UNITED STATES PATENT AND TRADEMARK OFFICE

APPLICATION NO.	FILING DATE	FIRST NAMED INVENTOR	ATTORNEY DOCKET NO.	CONFIRMATION NO.
10/517,845	12/15/2004	Arvo Jonkka	032221-055	1312
21839	7590	08/02/2006	EXAMINER	
BUCHANAN, INGERSOLL & ROONEY PC			MILLER, BENA B	
POST OFFICE BOX 1404			ART UNIT	
ALEXANDRIA, VA 22313-1404			PAPER NUMBER	
			3725

Office Action Summary

DETAILED ACTION

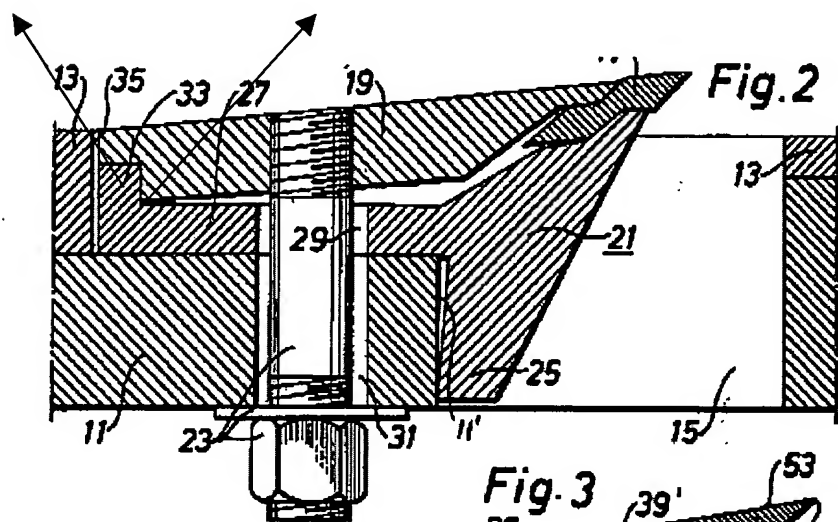
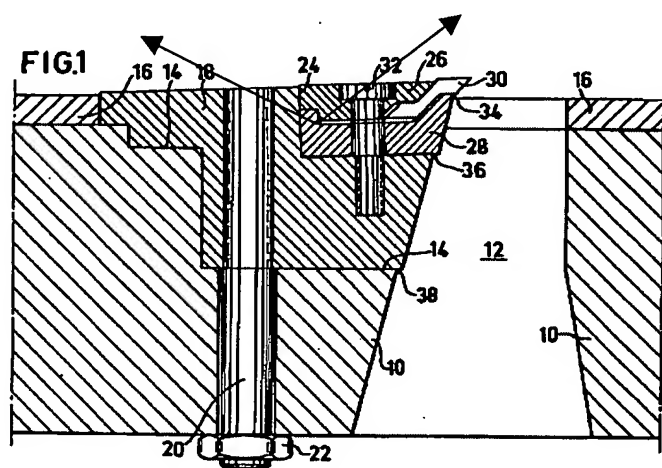
The device of either Holmberg or Svensson reads on the elements of the claimed invention including a method for clamping a knife on a chipper disk by forcing the knife in an inclined projecting position out from the disc against a wear plate fastened on the knife side of the disk, with a force substantially parallel to the axis of the disc, wherein said force parallel to the axis of the disc is exerted to the knife through a clamp having a contact to the wear plate, said contact being barred in the projecting direction to the knife wherein the force parallel to the axis of the disc is exerted to the clamp at a point towards the knife tip from said barred contact point in order to bring a turning moment to the clamp as seen in figure 1 of Holmberg or figure 2 of Svensson.

The device of either Holmberg or Svensson reads on the elements of the claimed invention including a knife disc (10 or 11), a wear plate (28 or 21), a knife (30 or 17), a clamp (26 or 19), a compressing means (20 or 23), a bracket (see marked copy of fig 1 of Holmberg or fig. 2 of Svensson), a matching groove, a cam and a projection. The clamp of Holmberg or Svensson is supported against a perpendicular direction, parallel with a compressive motion, by the bracket abutting the matching groove.
